SUBJECT: PRAIRIE ISLAND NUCLEAR GENERATING PLANT, UNITS 1 AND 2 - ISSUANCE OF AMENDMENTS RE: REVISION TO LOSS-OF-COOLANT (LOCA) ACCIDENT AND MAIN STEAM LINE BREAK (MSLB) ACCIDENT RADIOLOGICAL DOSE CONSEQUENCES ANALYSES AND AFFECTED TECHNICAL SPECIFICATIONS (TAC NOS. MD9140 AND MD9141)

Amendment No. 191  
License No. DPR-42

Amendment No. 180  
License No. DPR-60

SAFETY EVALUATION BY THE OFFICE OF NUCLEAR REACTOR REGULATION  
RELATED TO AMENDMENT NO. 191 TO FACILITY OPERATING LICENSE NO. DPR-42  
AND AMENDMENT NO. 180 TO FACILITY OPERATION LICENSE NO. DPR-60  
NORTHERN STATES POWER COMPANY - MINNESOTA  
PRAIRIE ISLAND NUCLEAR GENERATING PLANT, UNITS 1 AND 2  
DOCKET NOS. 50-282 AND 50-306

Figure 3.4.17-1 (page 1 of 1)  
Reactor Coolant DOSE EQUIVALENT I-131 Specific Activity  
Limit Versus Percent of RATED THERMAL POWER

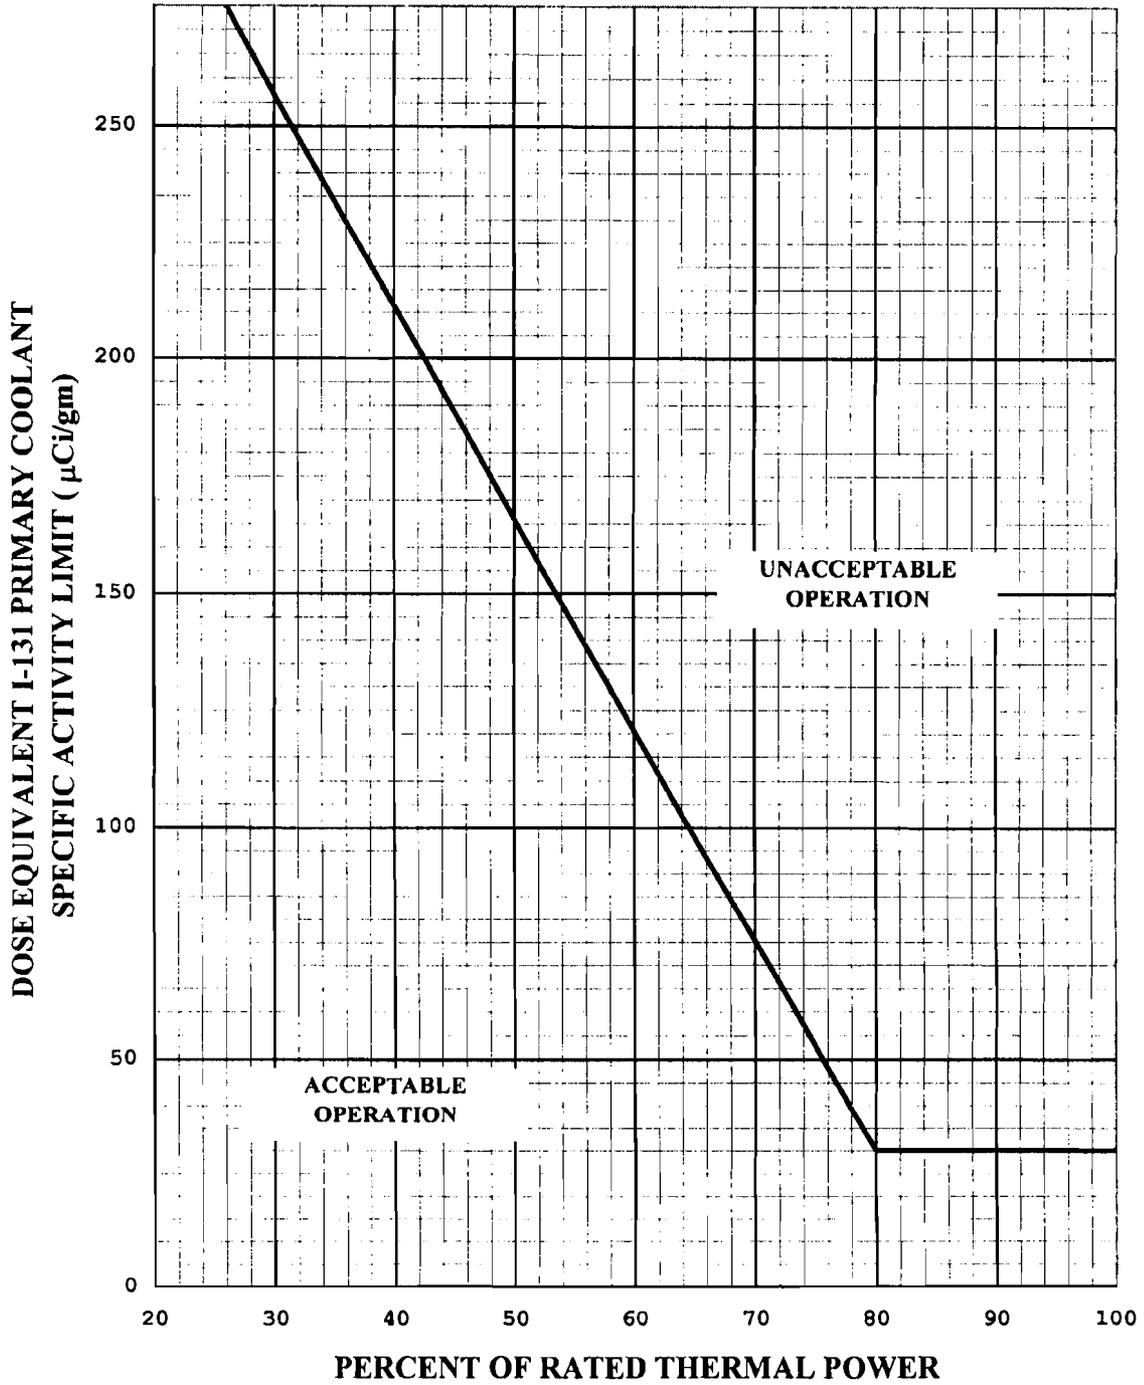
1. TS 3.3.5, "Containment Ventilation Isolation Instrumentation," by deleting this section in its entirety.
2. TS 3.4.17, "RCS Specific Activity," by revising the action limit in Condition A and the acceptance limit in Surveillance Requirement (SR) 3.4.17.2 from 1.0  $\mu\text{Ci/gm}$  dose equivalent I-131 (DEI) to 0.5  $\mu\text{Ci/gm}$  and revising Figure 3.4.17-1 by reducing the Acceptable Operation DEI from 60  $\mu\text{Ci/gm}$  to 30  $\mu\text{Ci/gm}$  for plant operations 80 to 100 percent of rated thermal power.
3. TS 3.6.3, "Containment Isolation Valves," by revising Action Statements and SRs to require the Containment Inservice Purge System (CIPS) to be blind flanged during the plant operating Modes and removing CIPS operational requirements.

1. Reduction in TS-allowed primary coolant activity desired by the licensee.
  - a. Proposed Change - Change the PINGP TS 3.4.17, "RCS Specific Activity," to reduce the limit on the primary coolant iodine concentration from 1.0  $\mu\text{Ci/gm}$  dose equivalent (DE) I-131 to 0.5  $\mu\text{Ci/gm}$  DE I-131.
  - b. Evaluation - This revision will implement a limit that is more conservative than the existing requirement. The NRC staff finds this change acceptable, as it has been properly modeled and accounted for in the licensee's revised design basis analysis, and the dose consequences remain within applicable acceptance criteria.
